SOUTHERN CALIFORNIA EDISON  
KERN RIVER NO. 3 HYDROPROJECT

DOCKET NO. P-2290-122

KERN RIVER BOATERS' COMMENTS, STUDY  
REQUESTS, AND INFORMATION REQUESTS IN  
RESPONSE TO PRELIMINARY APPLICATION  
DOCUMENT AND SCOPING DOCUMENT ONE

**Figure 1: Flows Above Fairview Dam, Summer 2021**

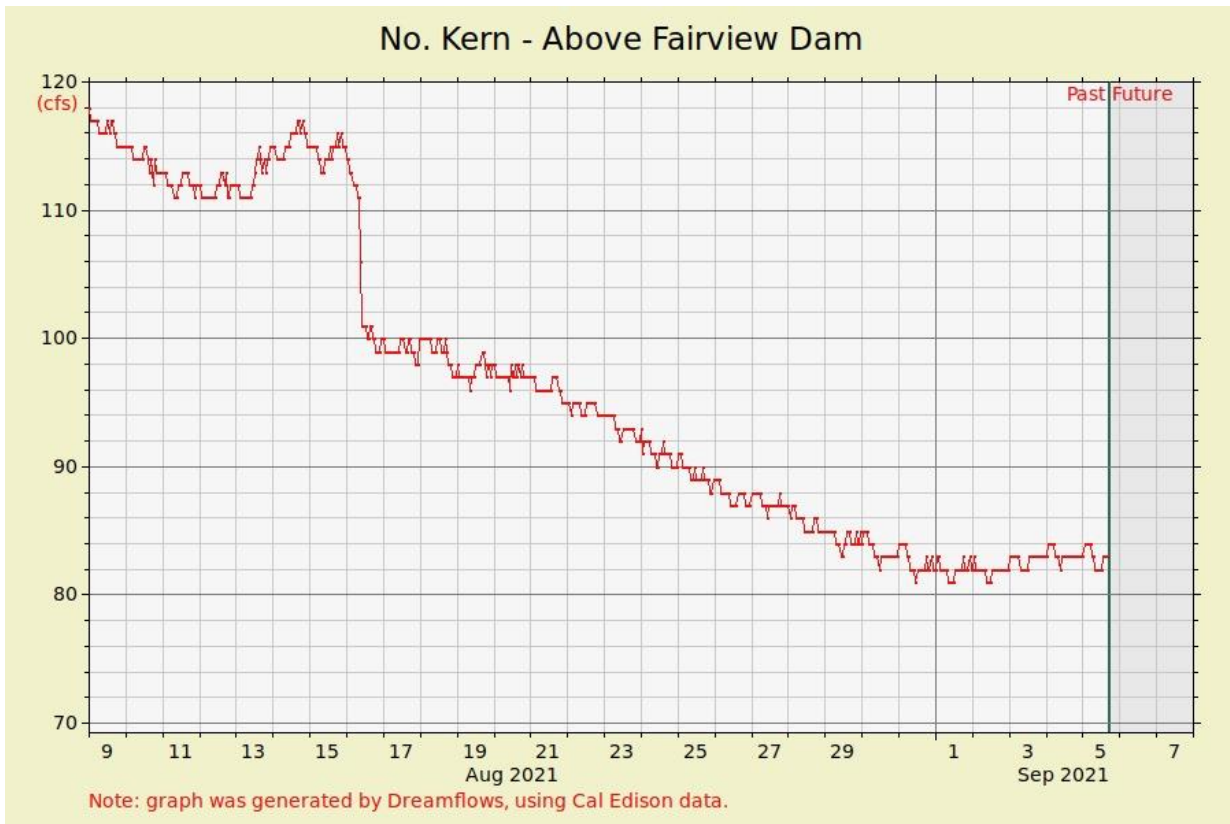
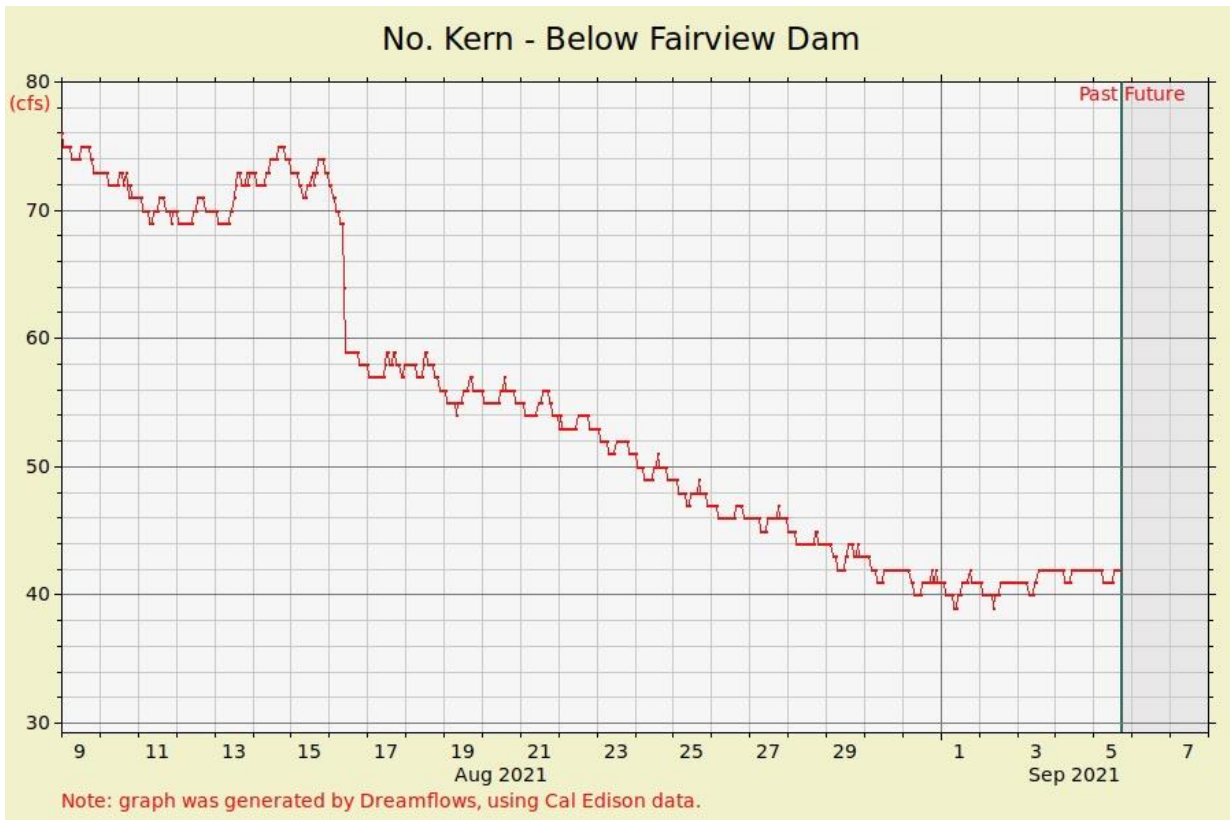
It is inaccurate and misleading to refer to Edison’s diversion of the first 35 cfs at Fairview Dam — which Edison has since increased to 40-45 cfs without a license amendment<sup>23</sup> — as a “hatchery flow” or to otherwise characterize the purpose of the diversion of that amount of water as being driven by hatchery operations. The hatchery does not require 35 (or 40 or 45) cfs to operate; the KR3 hydroelectric project does. Indeed, the hatchery has been closed for all of 2021.<sup>24</sup> Nevertheless, as the following graphs show, Edison continued diverting the first 42-43 cfs from the river, even as flows below Fairview Dam fell below 40 cfs during the hottest summer months when the natural fishery is most at risk:

Again, the hatchery was closed during the period of time depicted by the graphs above.

The record demonstrates that the central purpose of the first-in-priority 35 (now 40-45) cfs diversion is to provide for minimum power generation — not hatchery operations — and it should be licensed and characterized that way.

**Figure 3: A recent week (summer 2021) of extreme low flows in the fishery below Fairview Dam. Incoming flows above the dam were 80-84 cfs, but more than half was diverted for minimum power generation; note also, the hatchery was closed and had been closed since December 2020**

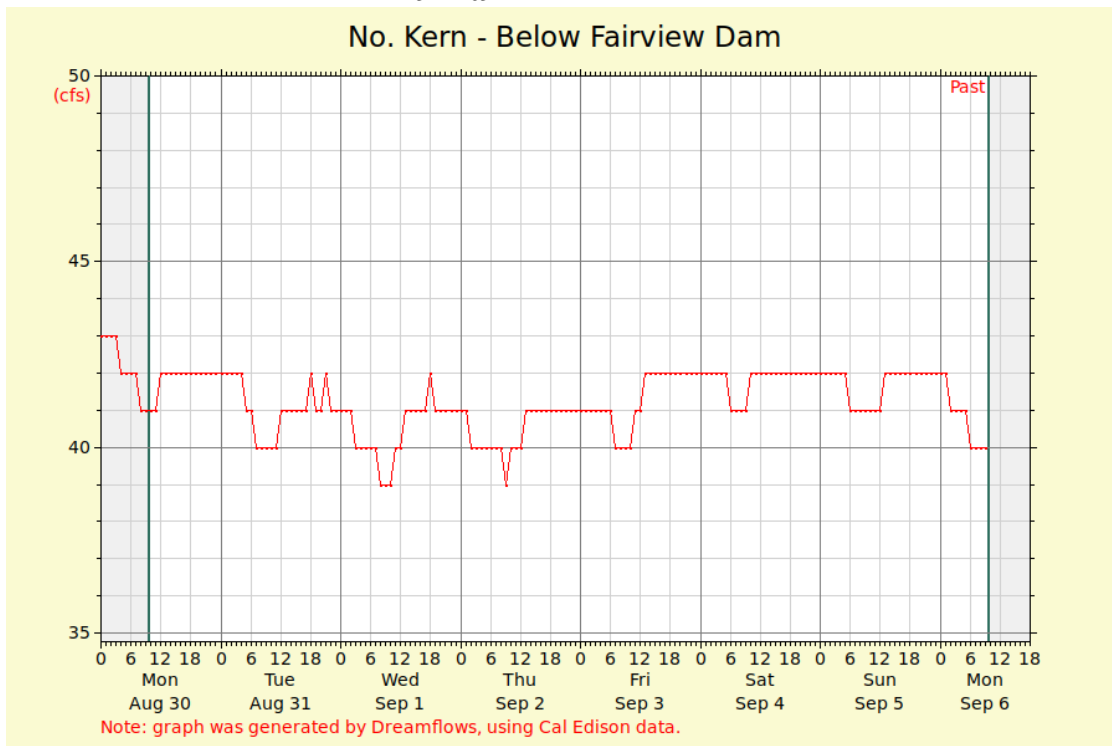
Instream flows are critical to the health of a fishery. The “buffer” taken on top of the minimum generation flow comes at the natural fishery’s expense when the fishery is most at risk: hot summer months of dry, low water years. In the summer of 2021, for instance, flows in the natural fishery dropped as low as 39 cfs. The buffer amounted to an *additional* 13-25% reduction of the fishery’s flow, on top of the near 50% reduction entailed by the first-in-line minimum power diversion of 35 cfs.

*Figure 13: KR3 Mean Annual Generation, 2001-2020*

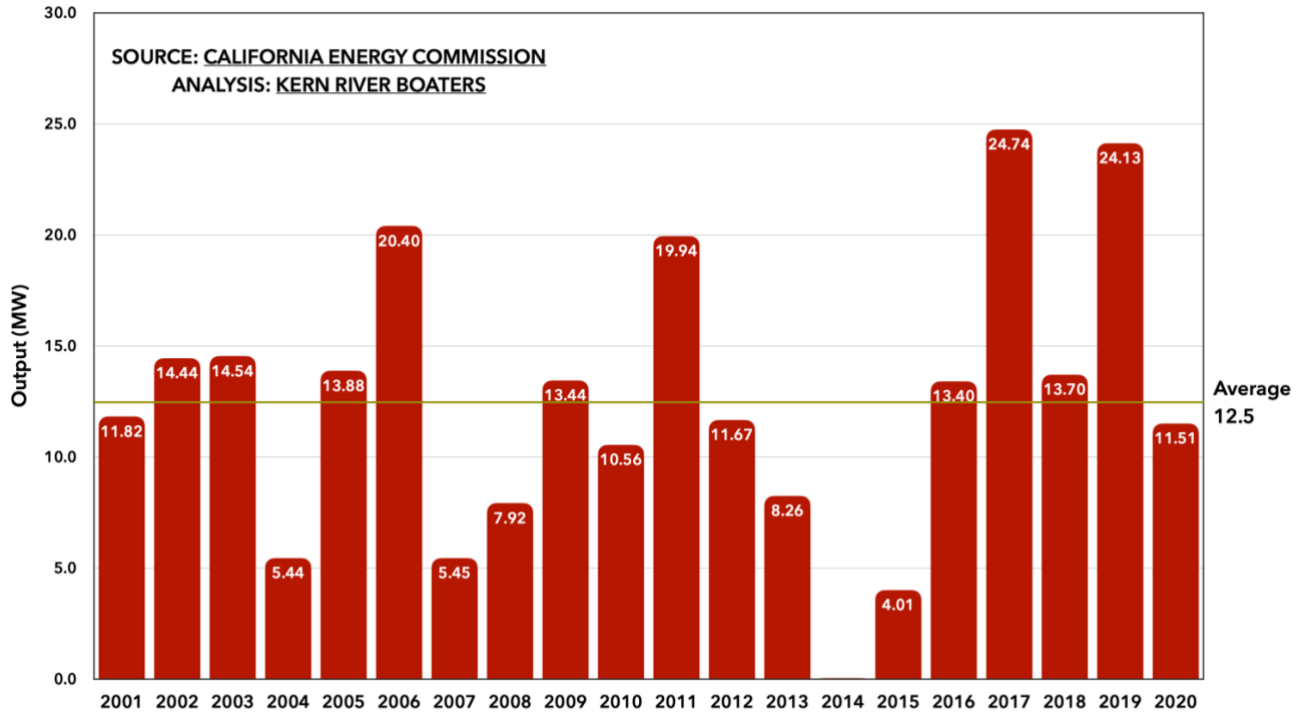
The project’s mean annual rate of output since 2001 has been about a third of its capacity, or 12.5 MW, with large fluctuations from zero (2014) to just under 25 MW (2017)<sup>59</sup>:

**Figure 17: Mean Inflow at Fairview Dam, 1997-2020<sup>62</sup>**

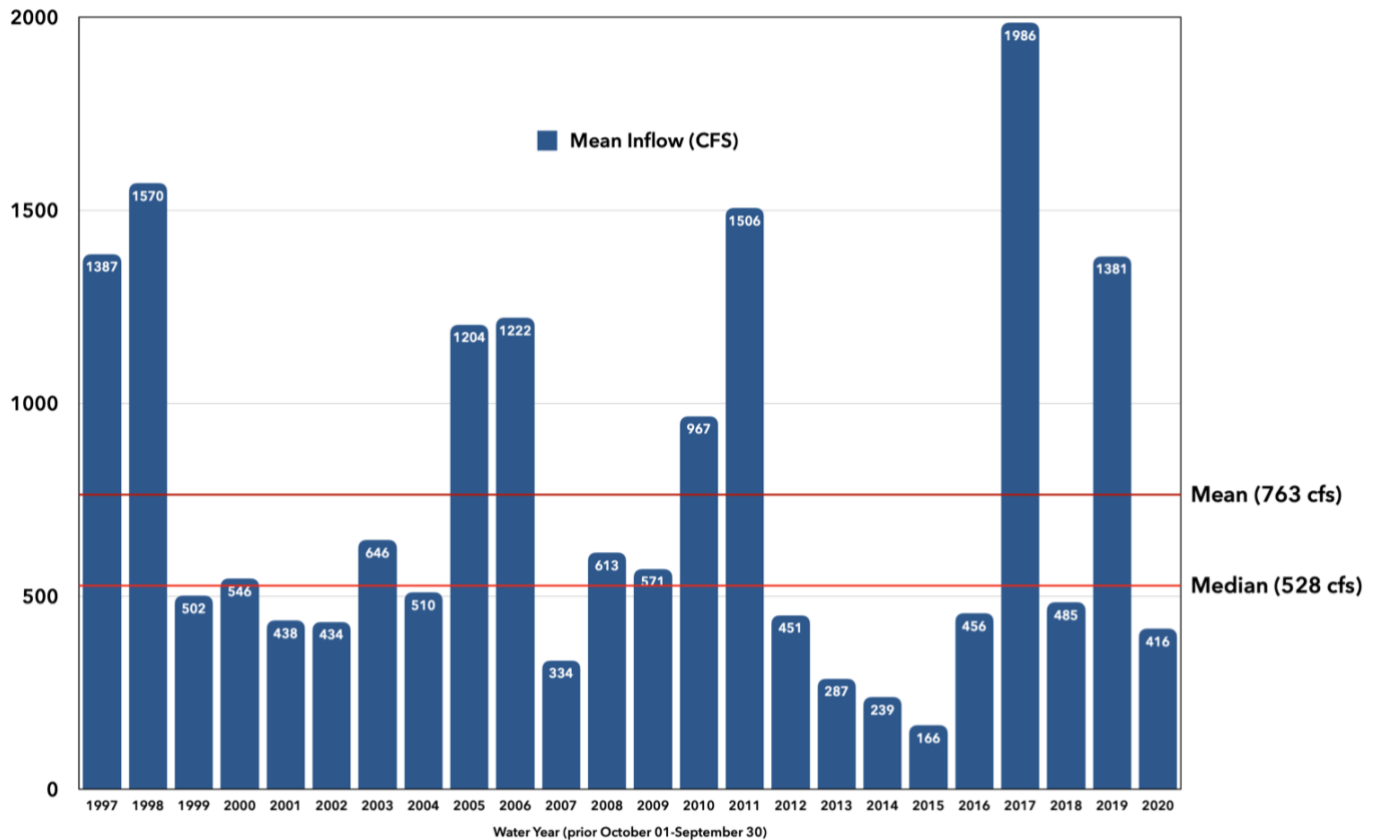
**KRB:** Edison’s POR is bookended by two consecutive high water years on the front end (1997 and 1998) and two of three years on the back end (2017 and 2019):

Data for water year 2020 — a dry year, which Edison chose not to include — has been available at USGS, and KRB includes it. The figure above illustrates a wide range of values between water years, from a mean flow of 166 cfs at Fairview Dam in the lowest year to a mean more than an order of magnitude greater in the highest: 1,986 cfs.

Figure 25: Comparison of KR3 Fish Flow Requirements, USFWS v. Settlement<sup>63</sup>

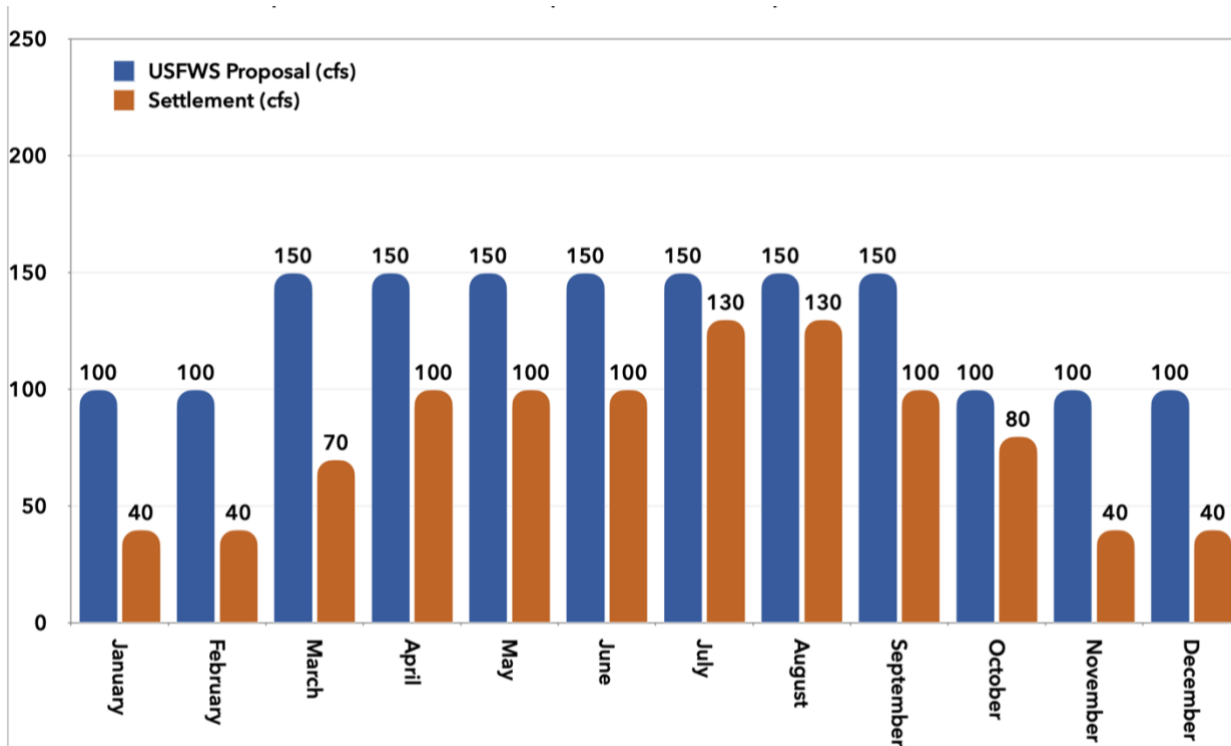
**KRB:** In the last proceeding, USFWS proposed a significantly more robust MIF:

**Figure 26: NFKR Segment 1 (Upper Half) IFIM Habitat Evaluation, 1991<sup>69</sup>**

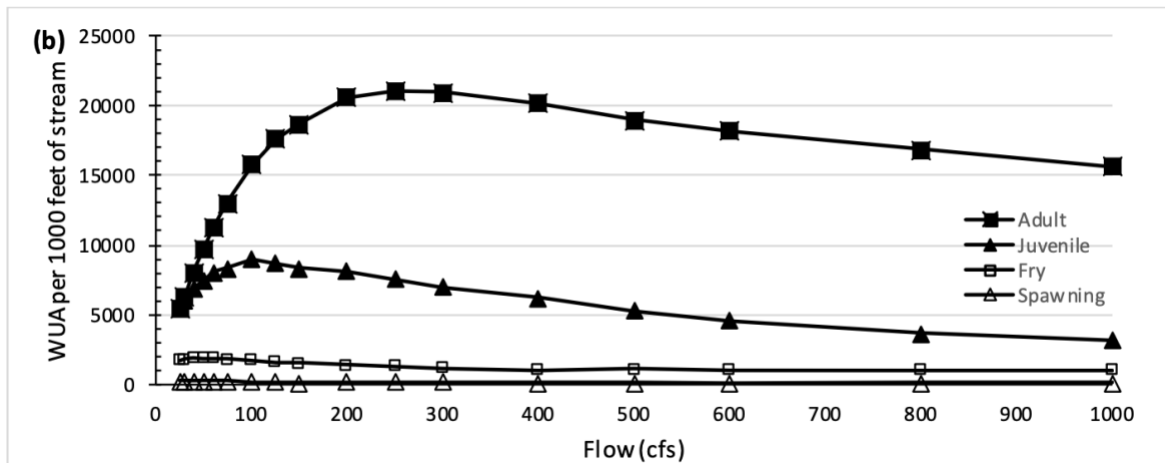
**KRB:** The 1991 IFIM study showed that life prospects for adult rainbow trout in the fishery below Fairview Dam begin to decline when flows move towards 200 cfs from 250 (Segment 1) or 400 (Segment 2) cfs. Life prospects then *sharply plummet* as flows fall below 200 cfs:

**Figure 32: NFKR Flows Above & Below Fairview Dam, Summer 2016**

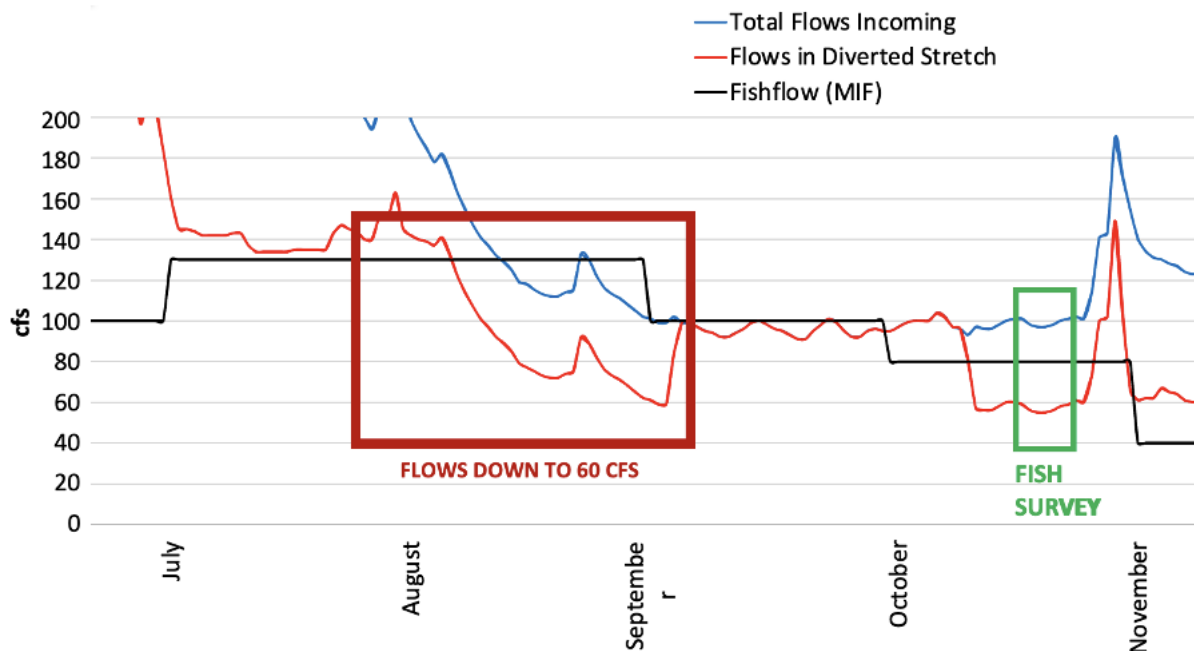
The most likely cause of the difference in population decline above and below Fairview Dam is the operation of the dam itself under the current KR3 license. The following chart compares flows above and below Fairview Dam for 2016, the year in which the trout population decreased by about half above the dam but by about 95% below it. Note how the minimum generation flow sets the water level more than 40 cfs below the MIF in August and early September — the hottest times of the year. Edison briefly gave up its minimum generation flow for five weeks prior to the study (September 04 through October 12), but even that couldn't fix the damage that had been done:

Figure 44: Median NF Kern Annual Exceedances, 1997-2020

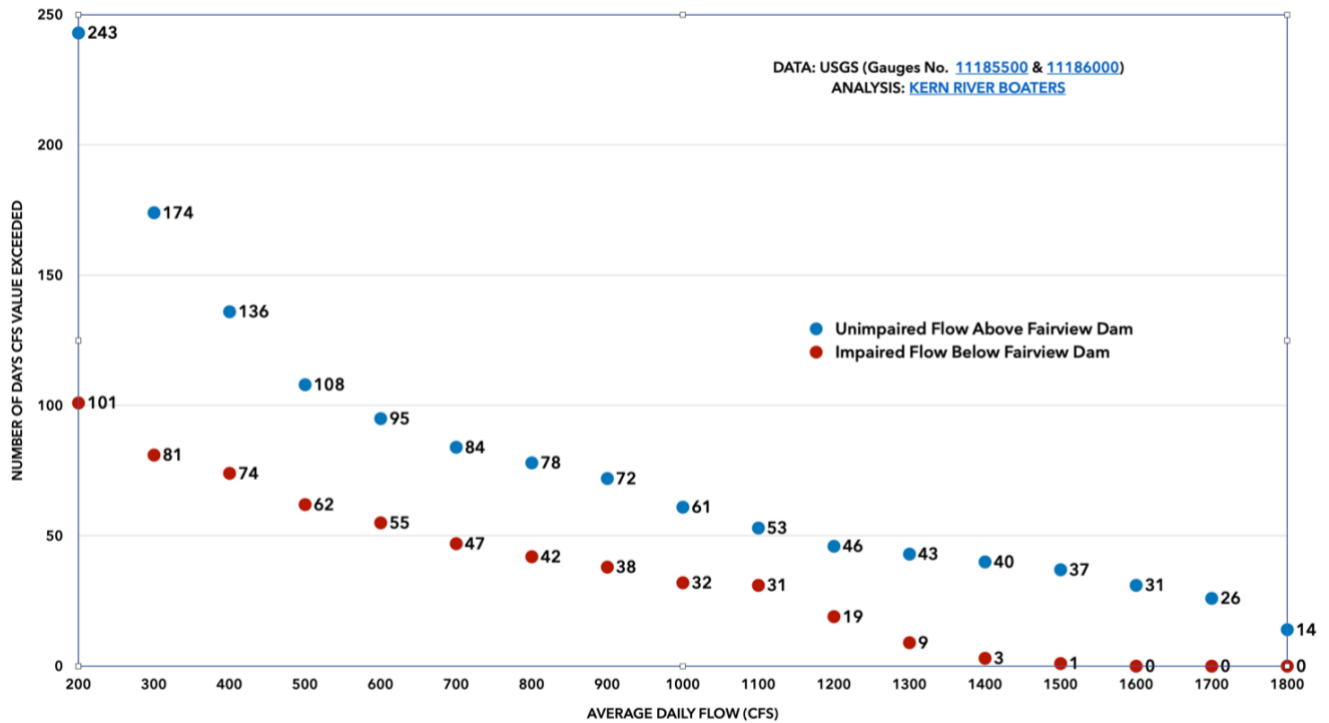
Median annual flows for the term of the present license (1997-2020) show that 243 days have an average daily flow above Fairview Dam of 200 cfs or more. That figure drops to only 101 days below the dam due to project operations:

Recall again that these figures are confounded because Edison has not provided peak daily flow information for the POR, because the project was offline for 1,455 of the 8,766 days in this record, and because it was partially offline for at least hundreds more. Even so, these figures show a vast inventory of days at all water levels upon which the NFKR would naturally offer whitewater boating opportunities that are denied to the public due to the operation of the project.

**Figure 45: Percentage of NFKR Exceedances Lost to KR3 Operations, 1997-2020, by Water Year Type (Thirds)**

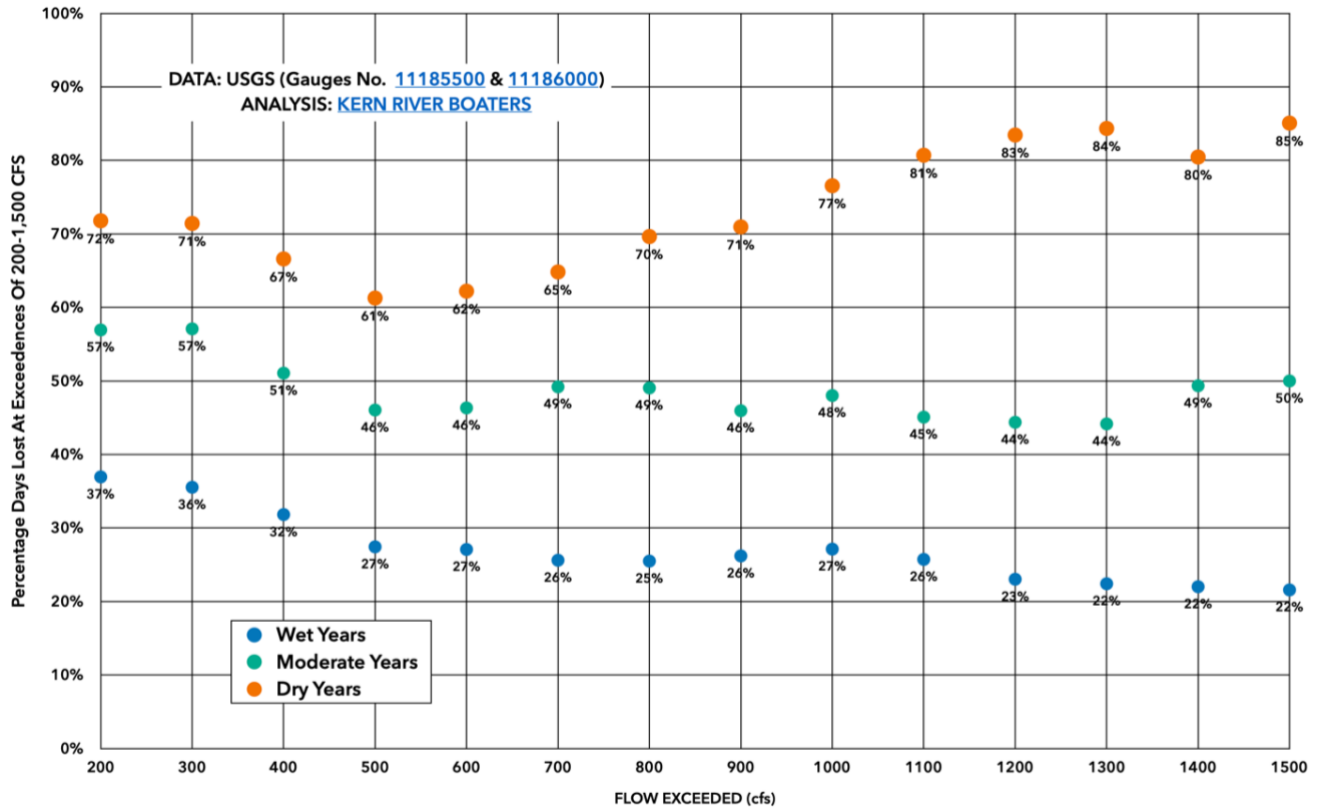
Finally, it is important to note that the project takes its biggest chunk out of recreational opportunities on the NFKR in low water years. The following chart compares the percentage of exceedances in the dewatered reach lost to project operations in high, moderate, and low water years over the POR:
